MEMORANDUM

Date:	August 20, 2021
To:	Chris Regan, Environmental Manager, IBR program
From:	Emma Johnson, Environmental Coordinator, IBR program Angela Findley, Environmental Lead, IBR program
Subject:	Screening and Evaluation of the “Common Sense Alternative II”

Figure 1: Common Sense Alternative II – Overview

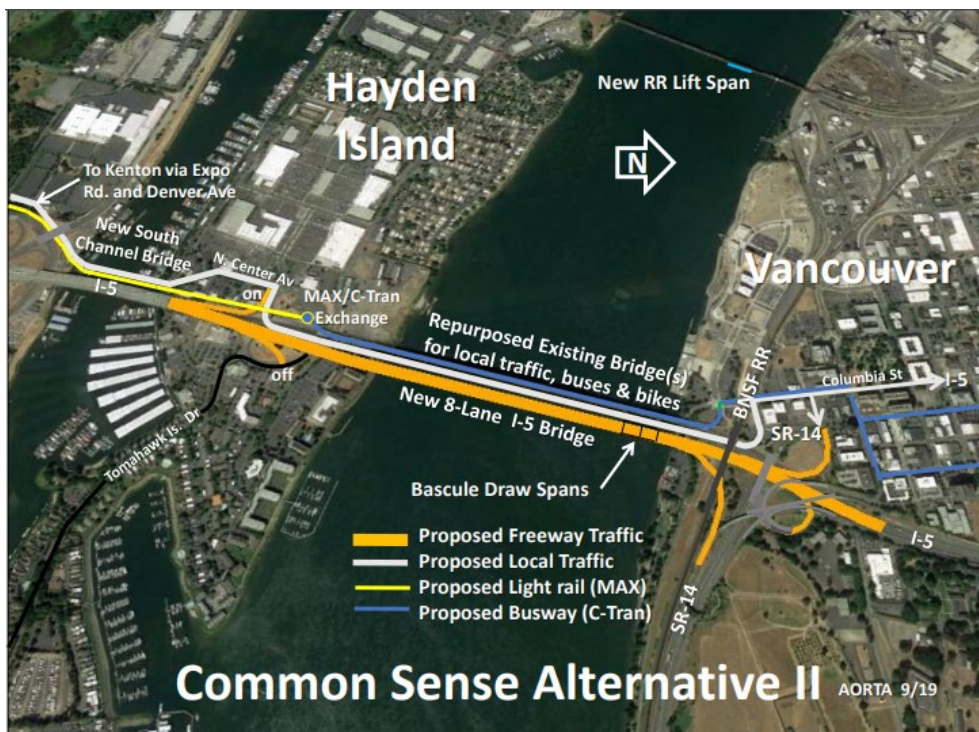
CSA II materials state that the addition of a lift span on the BNSF bridge would “allow all commodity barge traffic to navigate under the high spans of the existing Interstate Bridges and reduce the number of lifts by 90%”. While adding a bridge lift to the BNSF bridge would likely reduce some of the bridge lifts at the Interstate Bridge, many bridge lifts would still be required for bridge maintenance or when marine vessel heights exceed the vertical clearance provided by the bridge (without raising the lift span).

- **Vehicles, Freight, and Transit:** Traffic on the existing bridge would continue to be affected by bridge lifts. The bridge lifts would have substantial operational disadvantages for both light rail transit and/or bus rapid transit, interrupting service, and reliability.

As noted previously, under the CSA II any seismic upgrades to the existing bridge would be considered optional. However, any alternative that does not address the seismic deficiencies of the existing Interstate Bridge would not meet the program's Purpose and Need statement. Subsequent evaluations of seismic retrofitting have determined that seismic retrofits would be prohibitively expensive and would incur additional impacts to the environment (due to the need for expansion in the Columbia River). In addition, seismic retrofits may not be sufficient to reliably ensure that the bridge could handle a 500-year earthquake (with little to no damage) or a 2,500-year earthquake (with no collapse). Therefore, any alternative that involves the seismic retrofitting of the existing bridge does not meet the program's Purpose and Need statement.

This component of the CSA II calls for a supplemental bridge with a bascule lift span located upstream (east of) the existing bridge, which would be used for long-distance traffic. As detailed above (under "Repurpose the existing Interstate Bridge"), the CRC project team identified several downsides to the general concept of a supplemental bridge in any location, including increased impacts to land use and natural resources (detailed above).

Additional screening by the project team identified several deficiencies with the RC-8 component (Ficco and Osborn 2006). The need for accommodating marine traffic through bridge openings results in poor performance for five of the six Step A screening questions when compared to higher fixed-span components:

The memo concluded that low-level moveable spans carry significant costs to mobility, safety, freight economy, and financial resources with no benefits over a fixed span. A higher mid-level fixed span can perform the same function as a low-level moveable span at lower cost and with no significant differences in impacts to the surrounding communities. For these reasons, RC-8 was not recommended for continued development.

Under the CSA II, the existing NPH Bridge would be used to carry long-distance traffic between the Hayden Island-Vancouver bridge and Portland. It is not clear whether the CSA II involves retrofitting the existing NPH Bridge; however, the seismic deficiencies of the NPH Bridge would need to be addressed in order to meet the program's Purpose and Need statement. The program team is currently evaluating whether the NPH Bridge should be retrofitted or replaced as part of the IBR program.

The evaluation conducted under CRC of the group of components comprising the CSA II is still valid. The needs for the program have not changed, and the CSA II would not meet the program's Purpose and Need statement. A new bridge over North Portland Harbor is still under consideration to provide access to Hayden Island, and the IBR program would not preclude improvements to the BNSF bridge, such as adding a lift span to replace the swing span.

Figure 2: Common Sense Alternative II – Bridges

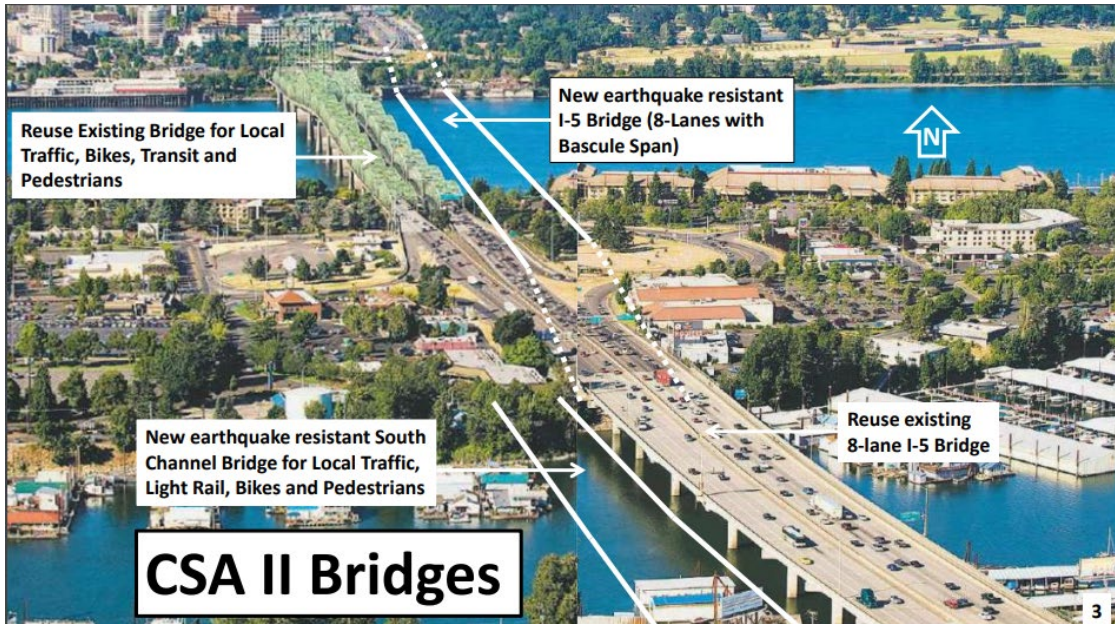
It is worth noting that the BNSF bridge is over 100 years old and likely seismically vulnerable, similar to the Interstate Bridge. It is not certain that BNSF, federal agencies, and/or the state departments of transportation would invest in a new movable span with the balance of the bridge over the river (and the bridge over the slough) remaining as is. As documented in the 2011 EIS, a replacement crossing would require fewer piers, creating less of an obstacle to river navigation than the existing bridge or a supplemental crossing. In addition, the new primary channel under the I-5 crossing would have a better alignment with the channel through the BNSF railroad bridge, which would improve navigation even though the two crossings would be slightly closer together (CRC 2011a).

The CRC component studied would be located immediately east (upstream) of the existing Interstate Bridge. The component was envisioned as a low-level bridge (meaning it would not be high enough to accommodate all marine traffic) and would provide approximately 65 feet of vertical clearance for traffic traveling down the Columbia River. The moveable portion of the bridge would be opened to allow marine traffic taller than 65 feet to pass through the channel. RC-8 passed the Step A screening and was recommended for further study, however it received scores of "Unknown" for question 4 (does the component improve safety and decrease vulnerability to incidents?) and question 6 (does the component reduce seismic risk of the I-5 Columbia River Crossing?).

Q1. Does the component increase vehicular capacity or decrease vehicular demand within the Bridge Influence Area? Moveable spans require continued I-5 closures during bridge openings or continued marine restrictions when the bridge must remain closed. Bridge openings have a negative impact on increasing vehicular capacity within the Bridge Influence Area.

Q2. Does the component improve transit performance within the Bridge Influence Area? Bridge openings have a negative impact for maintaining speed and reliability for transit that uses I-5 within the Bridge Influence Area.

Q3. Does the component improve freight mobility within the Bridge Influence Area? Bridge openings have a negative impact for maintaining speed and reliability for freight mobility within the Bridge Influence Area. Even though bridge openings may be restricted to off-peak periods, freight traffic also relies on off-peak periods for maximum efficiency.

Q4. Does the component improve safety and decrease vulnerability within the Bridge Influence Area? Some crashes can be attributed to the queuing that occurs following each bridge lift, and those crashes would continue with a new moveable span bridge. The need for marine traffic to rely on bridge openings also increases risk to marine navigation. For a bascule-type span, there would be intermittent encroachments into Pearson's airspace during bridge openings. In contrast, a fixed-span at a minimum would maintain the existing airspace encroachment condition with a supplemental bridge (one that kept the existing bridges), and with a replacement bridge it would actually serve to enhance the safety by eliminating the existing airspace encroachment.

Q5. Does the component improve bicycle and pedestrian mobility within the Bridge Influence Area? A fixed span would provide better connectivity for bike and pedestrian facilities as it eliminates the potential for interrupted travel associated with low-level moveable bridges.

Although cost was not a Step A screening criteria, it was estimated in 2005 that the construction cost for a moveable span is in the range of \$100 million more than a fixed span and that operations and maintenance for the moveable span would be in the range of \$400,000 more per year.
